# ARCHITECT'S SUPPLEMENTAL INSTRUCTION NO. 4

**DATE:** November 07, 2023 **PROJECT NO: 230117**

RE: Streets of West Pryor - Lot 5 Core & Shell

FIRST FLOOR PLAN

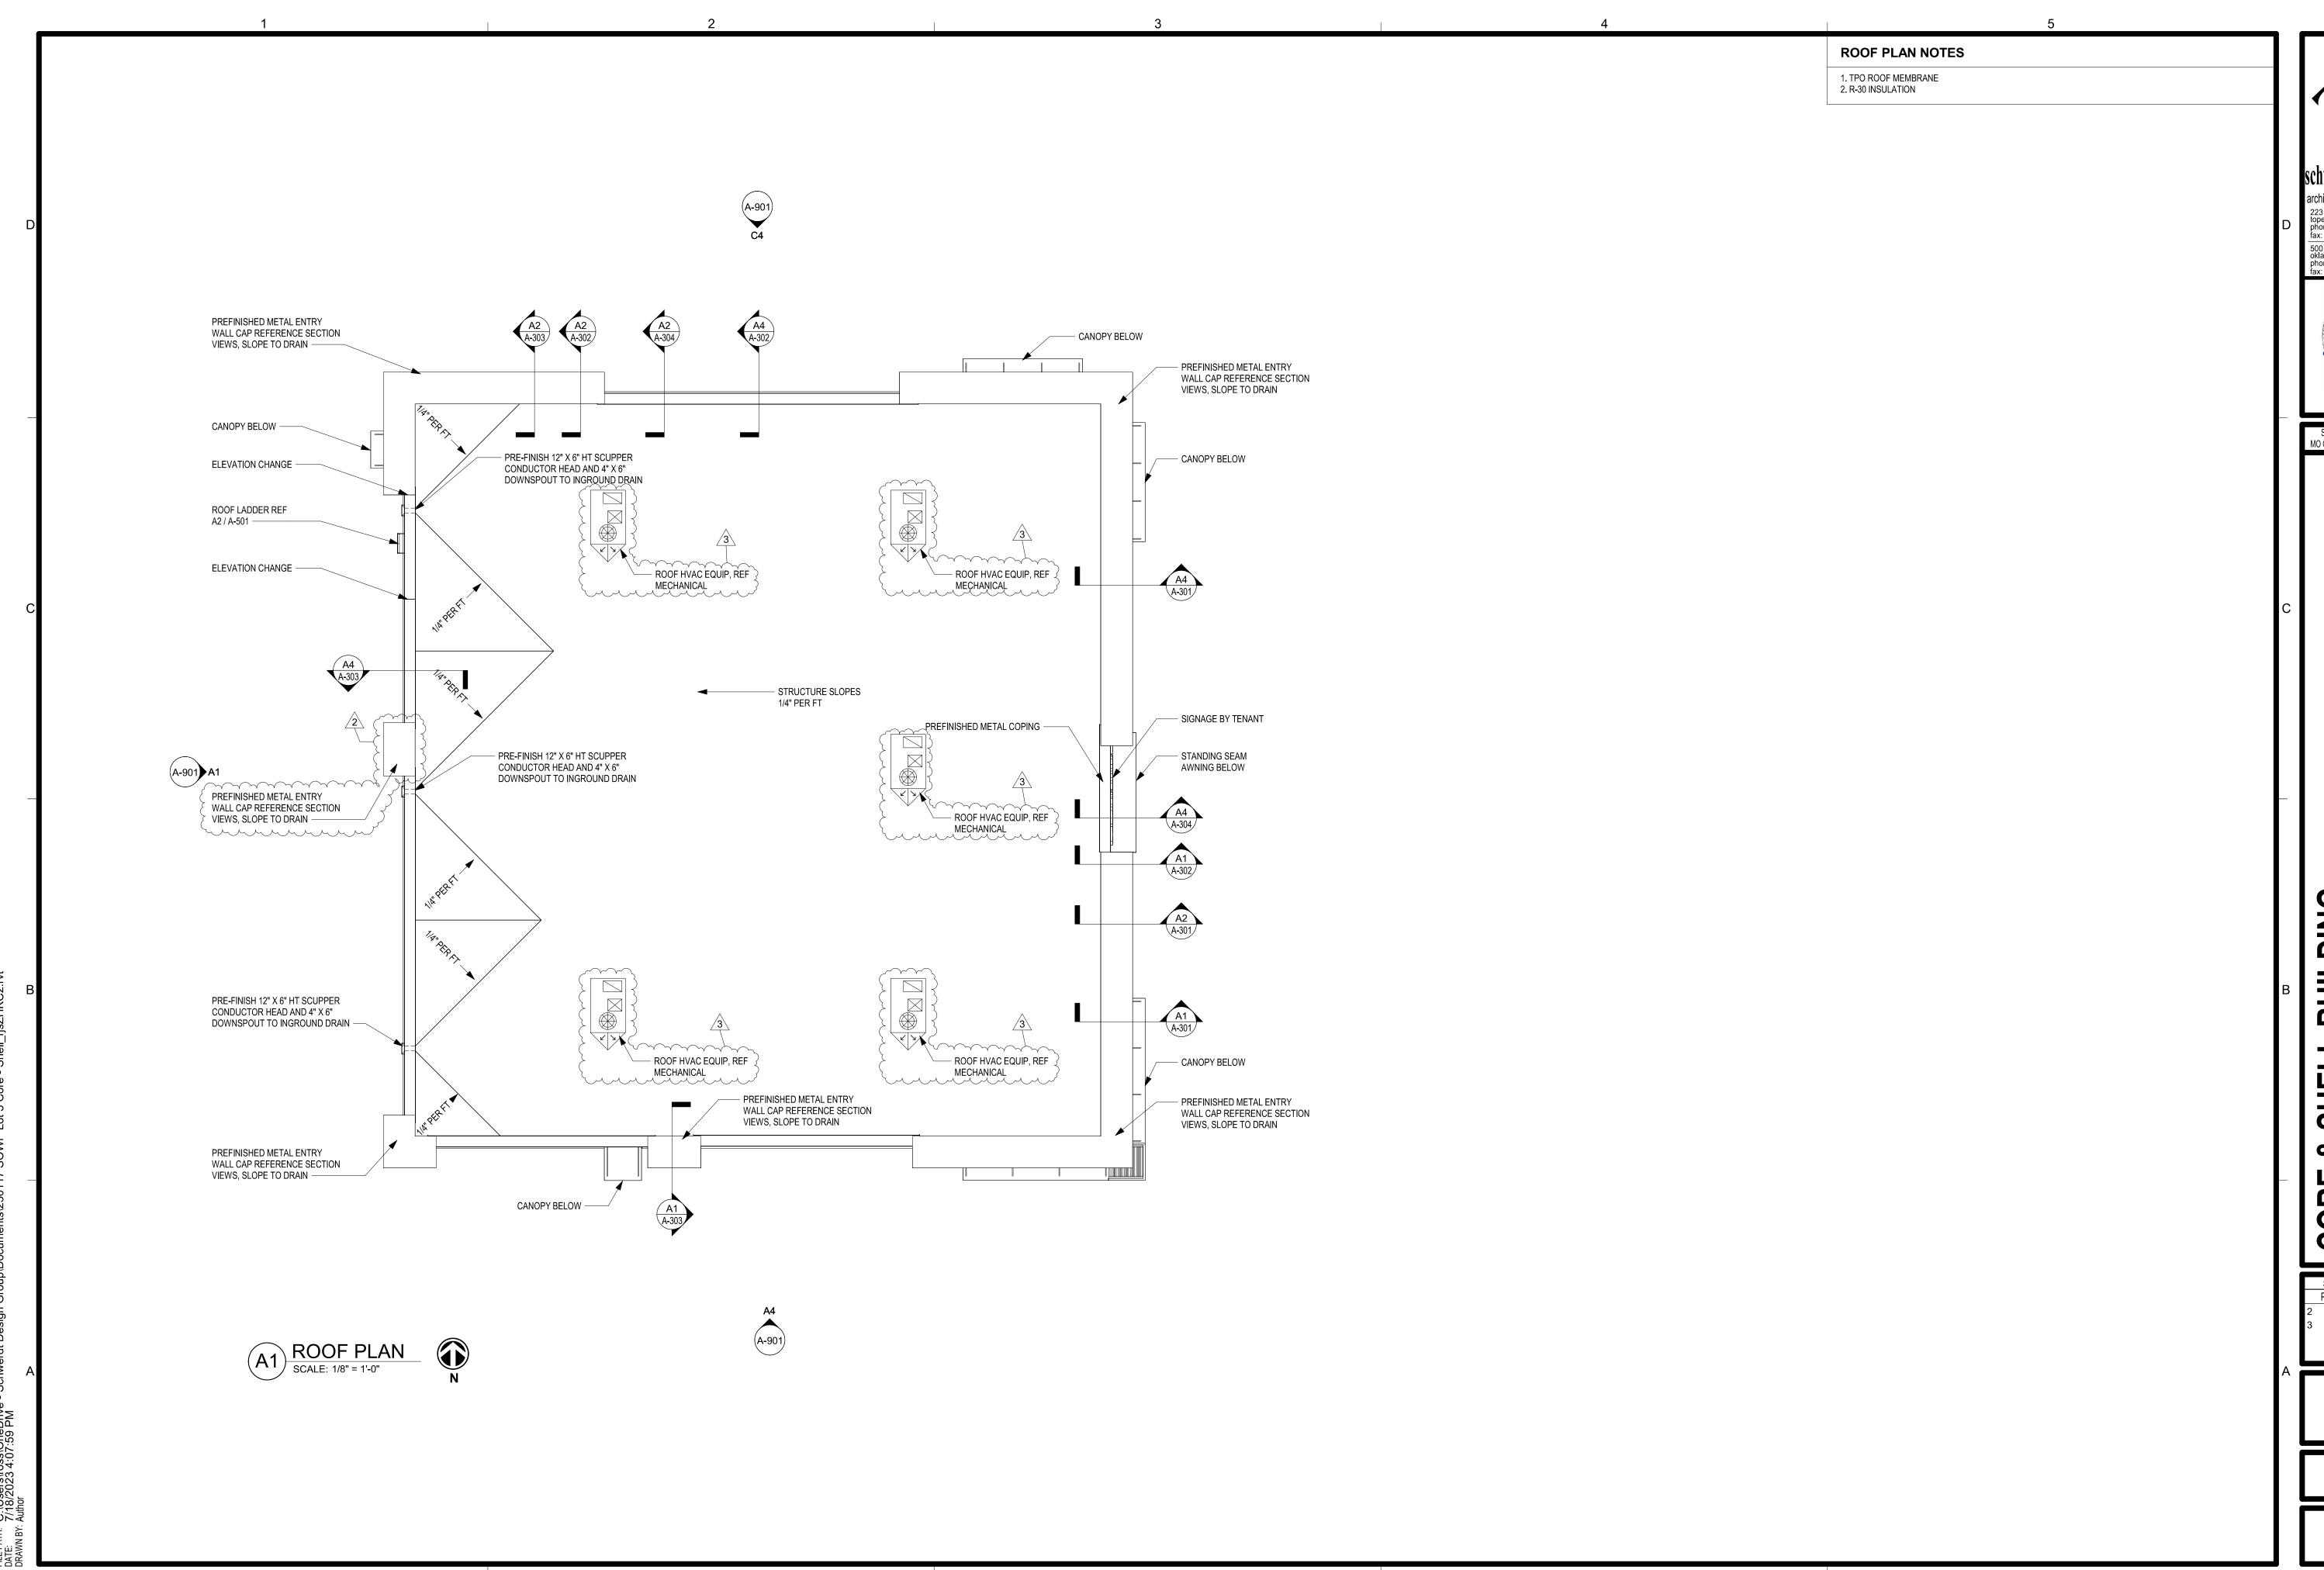
- A-1 Sheet G-001 Drawing A3-Code Plan changed from 3 tenant building to 2 tenant building.
  - A-1.A Drawing A3-Code Plan updated egress load tags.
- A-2 Sheet A-101 Floor changed from 3 tenant building to 2 tenant building. Including removal of fire demising wall, restroom and mechanical room.
  - A-2.A Room tags updated to illustrate proper Suite nomenclature and square footage.
- A-3 Sheet A-201 Drawing C1-East Elevation update illustrating change to Stone wainscot and EIFS 1 at previous brake metal pilaster.
  - A-3.A Drawing C1-East Elevation changed from 3 tenant building to 2 tenant building and tenant signage updated on elevation.
- A-4 Sheet A-401 Removed from scope.

A-1 Sheet A-101 – Updated location of future pass-through openings on Suite C's South demising wall.

- A-1 Sheet A-101 Future pass-through openings added on East and West ends of Suite C's South Demising wall.
  - A-1.A Key plan note #2 for Future pass-through added to Keyed Plan Notes legend.
- A-2 Sheet A-102 RTUs rotated 90 degrees for structural support purposes.
- A-3 Sheet A-201 Door C101 update to be 7' and Tempered Glass.
  - A-3.A Reference to MEP exterior utilities indicated on West Elevation Drawing A1.
- A-4 Sheet A-601 Door schedule updated to represent C101 door as 7' and Tempered Glass.

A-301

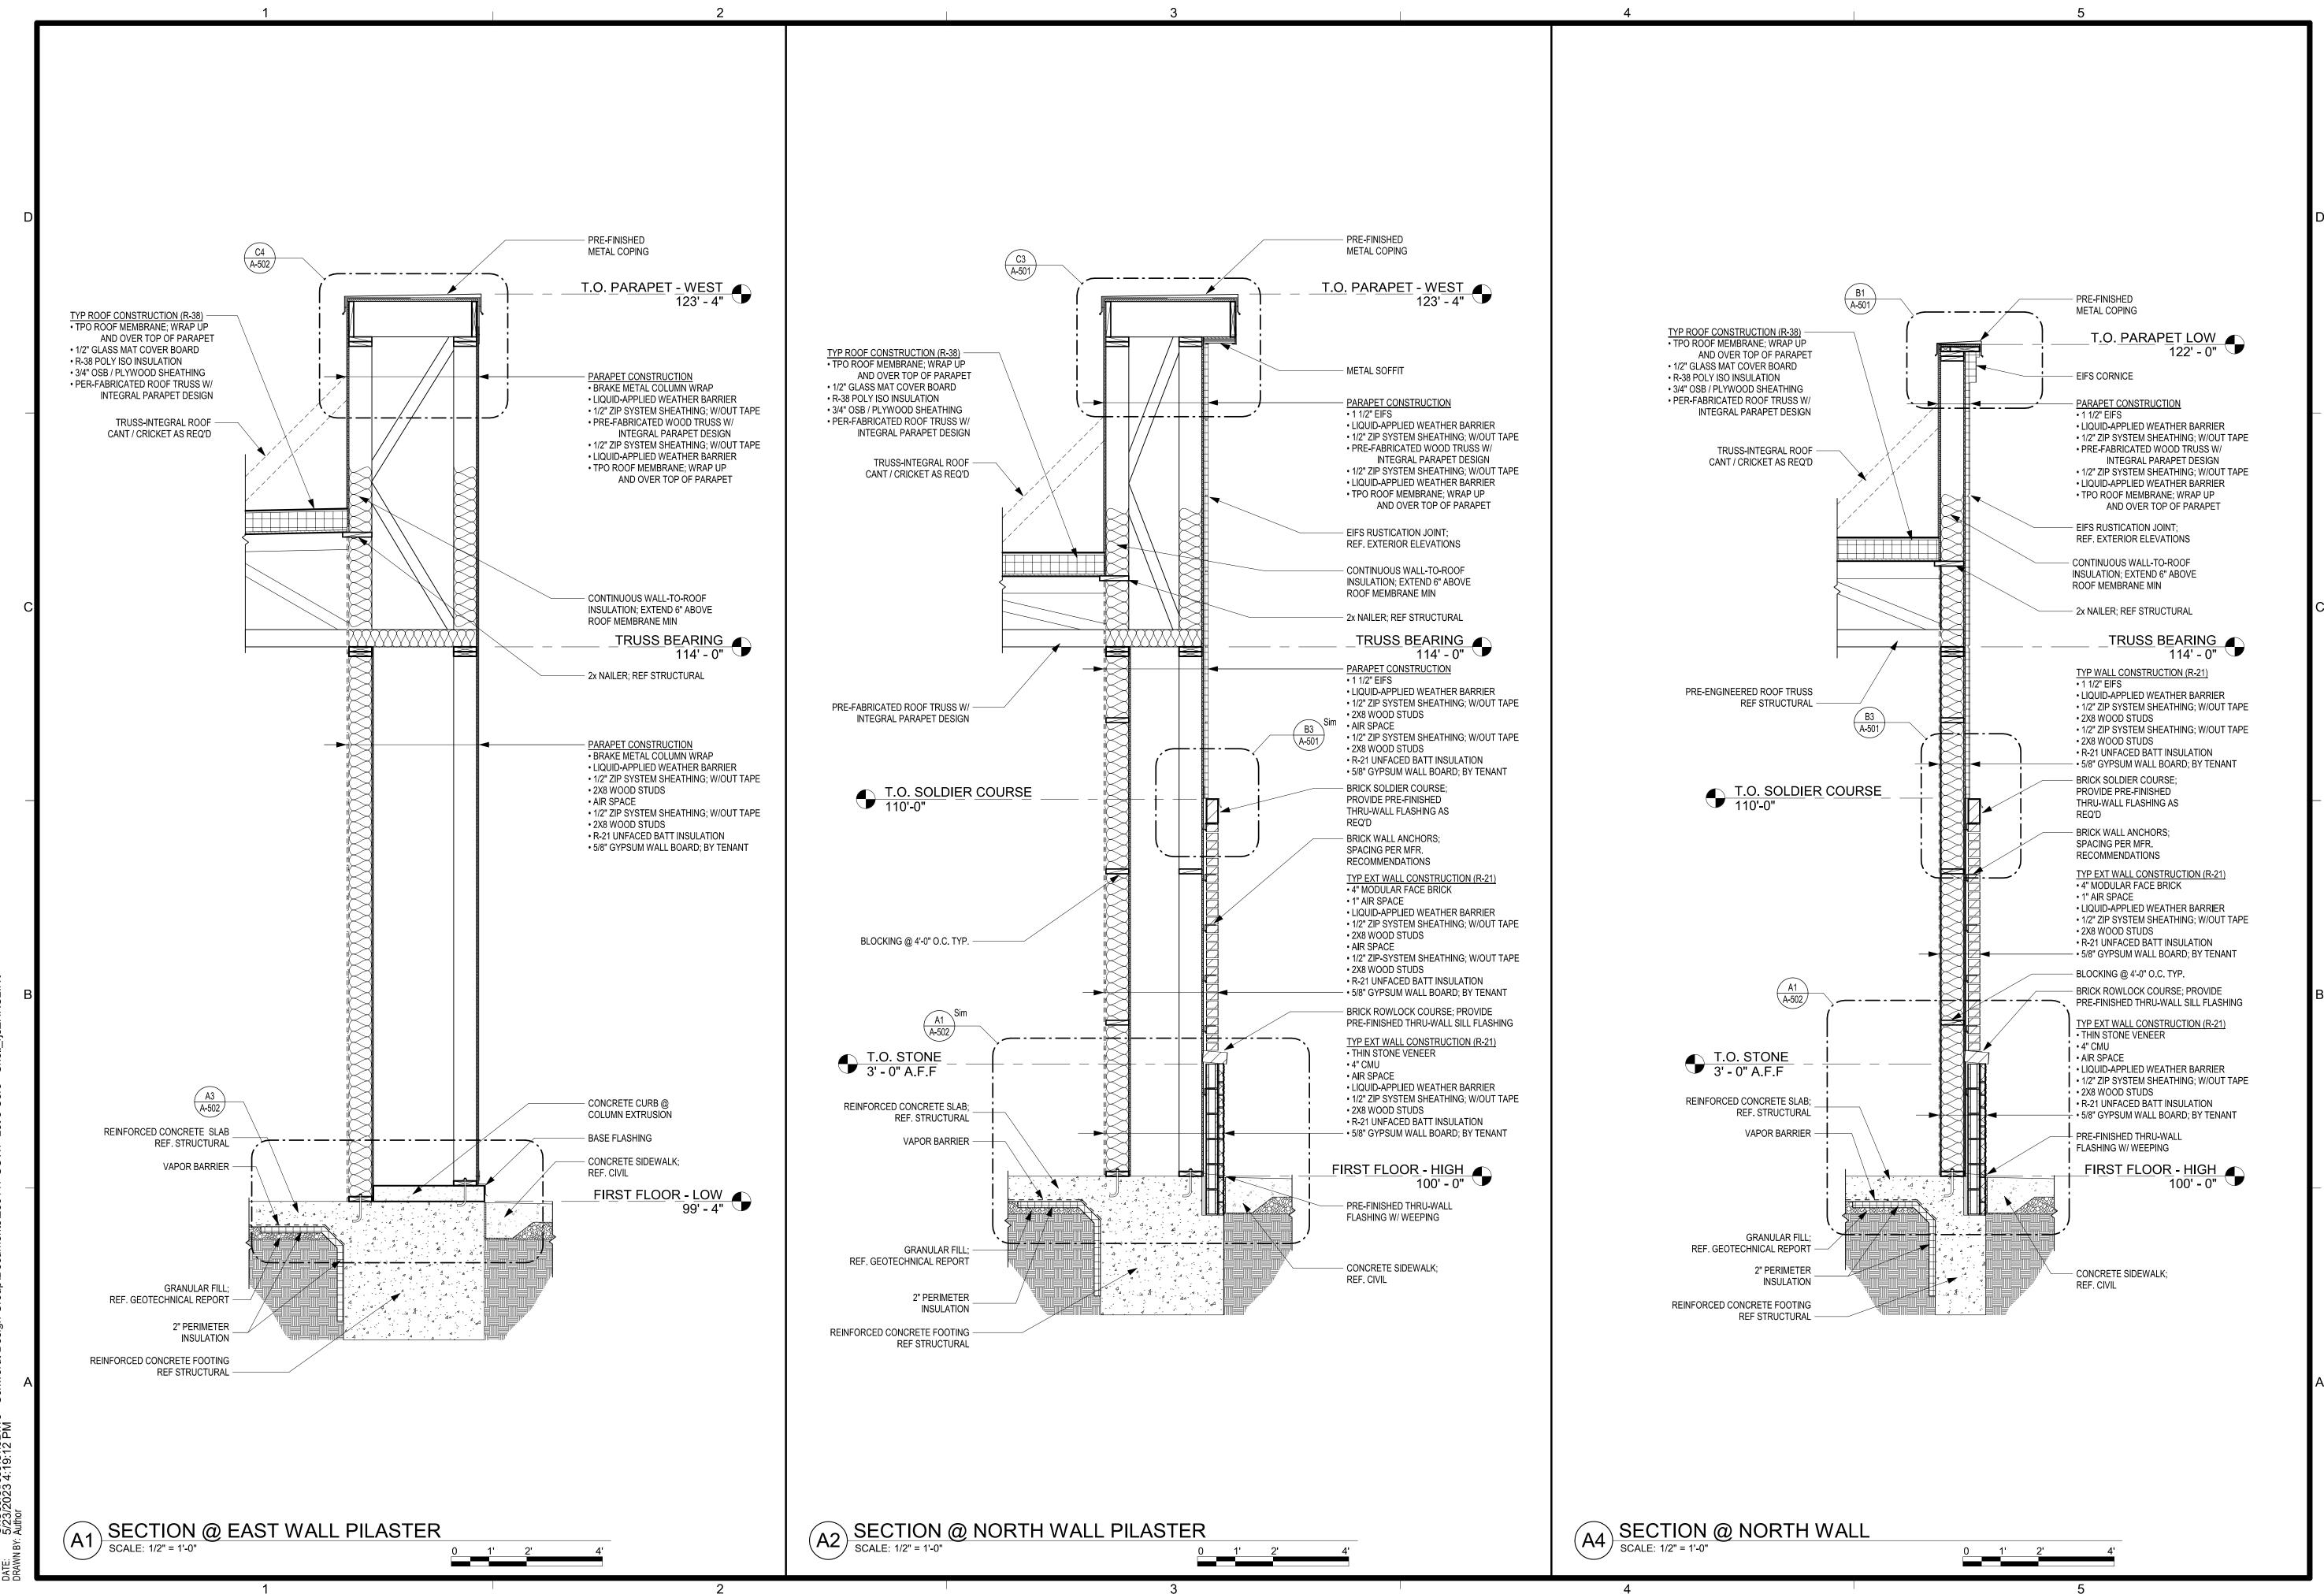
- A-1 Sheet A-101 UL Fire rated wall assembly information has been added to partition type P1.
  - A-1.A Partition types P2 & P3 have been added to partition type legend.
  - A-1.B Partition types P2 & P3 have been tagged in plan.
- A-2 Sheet A-102 Pilaster added to West wall.
- A-3 Sheet A-301 Wall construction updated to clarify horizontal lap aluminum siding.
